# Access Compliance Report

## Public Rights-of-Way

| Intersection ID: 46206 | Main Street: LOROPETALUM_RD | Cross Street: SNOWBELL_CT | Location: NE           |
| ADA ID: 763697D85EC0   | Ramp Type: BlendTrans1      | Initial Pass/Fail: Pass   | Overall Compliance: No |

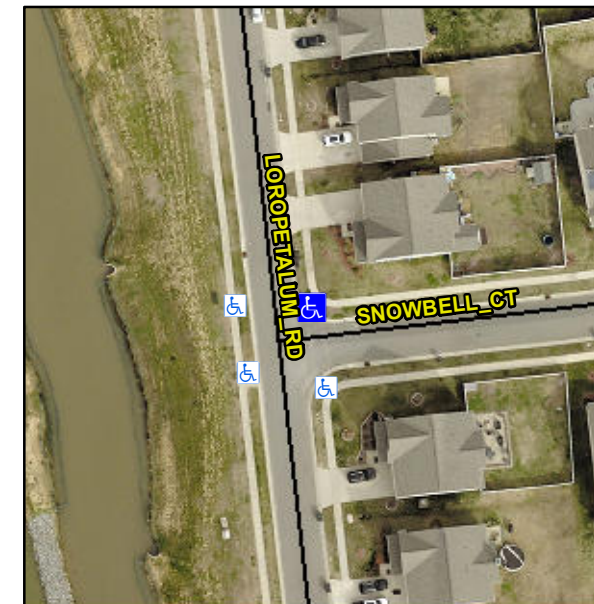
**Not Found, R304.5.3, R305.2, R302.7, R302.7.2, R304.5.4**

| Compliance | Description           | Data   | Compliance | Description                 | Data   |
|------------|-----------------------|--------|------------|-----------------------------|--------|
| Yes        | Ramp Width (in)       | 48.5   | No         | BlendTrans XSlope (%)       | 2.7    |
| No         | Landing X Slope (%)   | 3.6    | Yes        | DWS Full Width?             | Yes    |
| No         | Gutter Ponding?       | Yes    | No         | Gutter Slope (%)            | 6.8    |
| No         | Gutter Lip Ht (in)    | 2.0    | No         | Gutter X Slope (%)          | 4.0    |

**Remove & Replace Curb Ramp With Two New Directional Ramps or Equivalent. Remove & Replace Gutter.**
